SUBJECT: Forwards Errata & Addenda Sheet 2 to NEDO-22128, "GE BWR
 Extended Load Line Limit Analysis for Susquehanna Steam
 Electric Station Unit 1," in response to NRC questions re
 discrepancies between FSAR & rept.

SUSQUEHANNA STEAM ELECTRIC STATION
ADDITIONAL INFORMATION ON PROPOSED AMENDMENT 19
ER 100450 FILE 841-8
PLA-1792

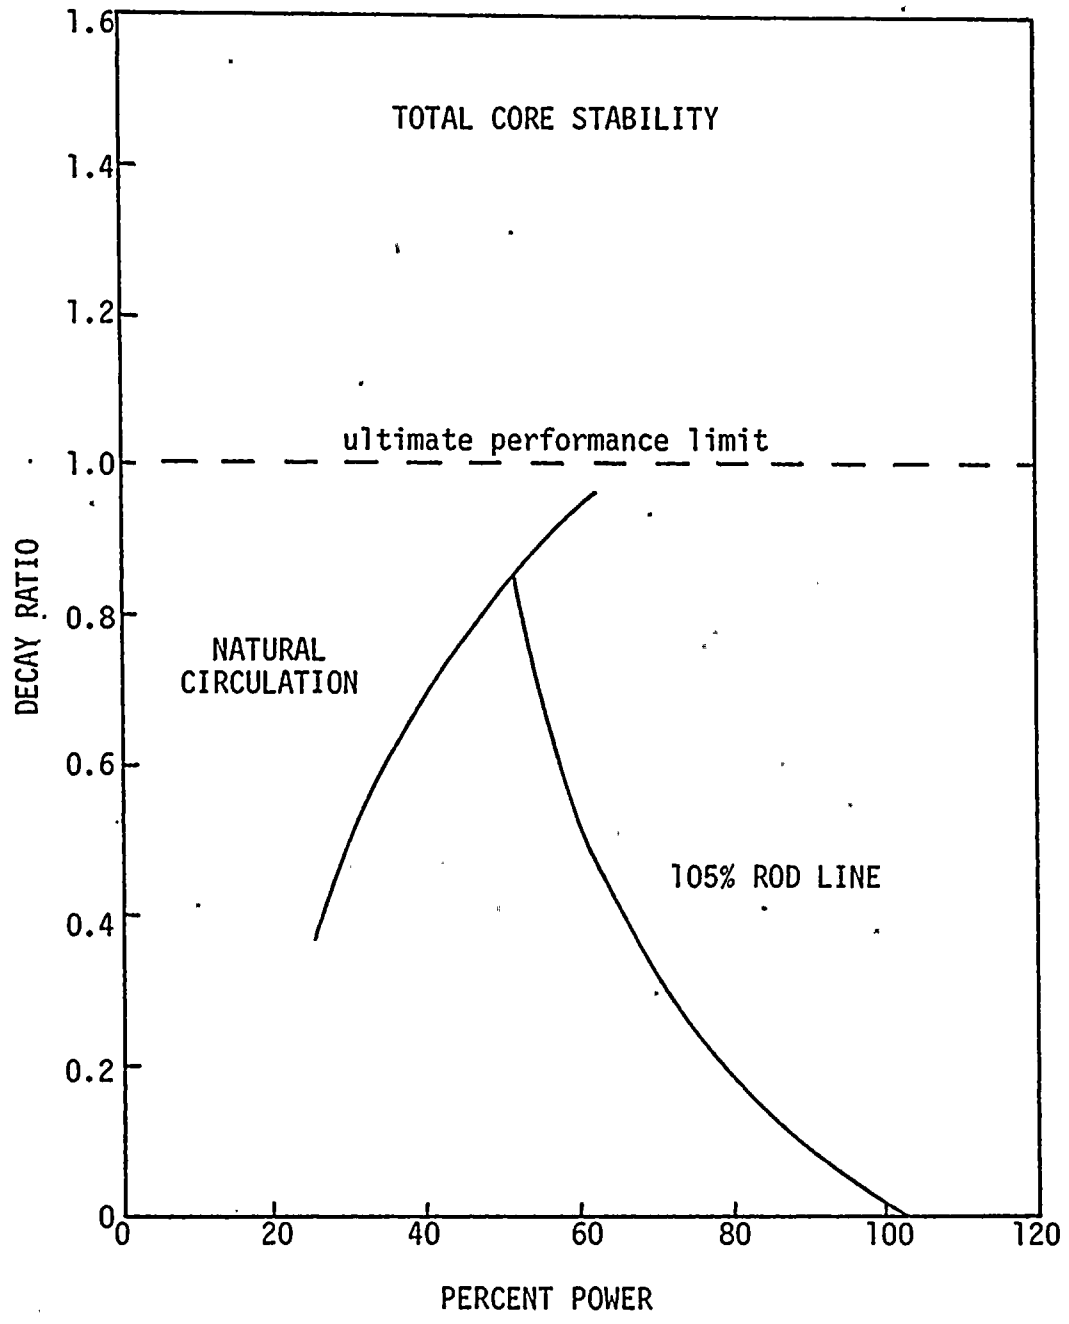
The stability analysis performed for the Susquehanna FSAR in 1976 used a fuel gap conductance of 533.5 BTU/hr-ft²-°F. This is approximately the same value which is currently used correctly for the FSAR transient analyses. This gap conductance was based on the core average GEGAP analysis value, which was the procedure in use at that time.

Since that time, however, it was determined that a more appropriate value to use for the gap conductance is 1000 BTU/hr-ft²-°F, which is used in NEDO-22128. Justification for this value is described in General Electric NEDE-20944-P (BWR/4 and BWR/5 Fuel Design, 1976) and also in General Electric NEDE-23786-1-P (Fuel Rod Prepressurization Amendment 1, 1978) for the fuel design in use at Susquehanna SES. Both of these GE Company - Proprietary documents have been previously submitted to NRC.

Based on this information, FSAR Subsection 4.4.4.6.6 and Figure 4.4-6 will be changed (see revised Figure 4.4-6 attached). General Electric has also revised NEDO-22128 to be more consistent with the FSAR (also attached, 3 pages).
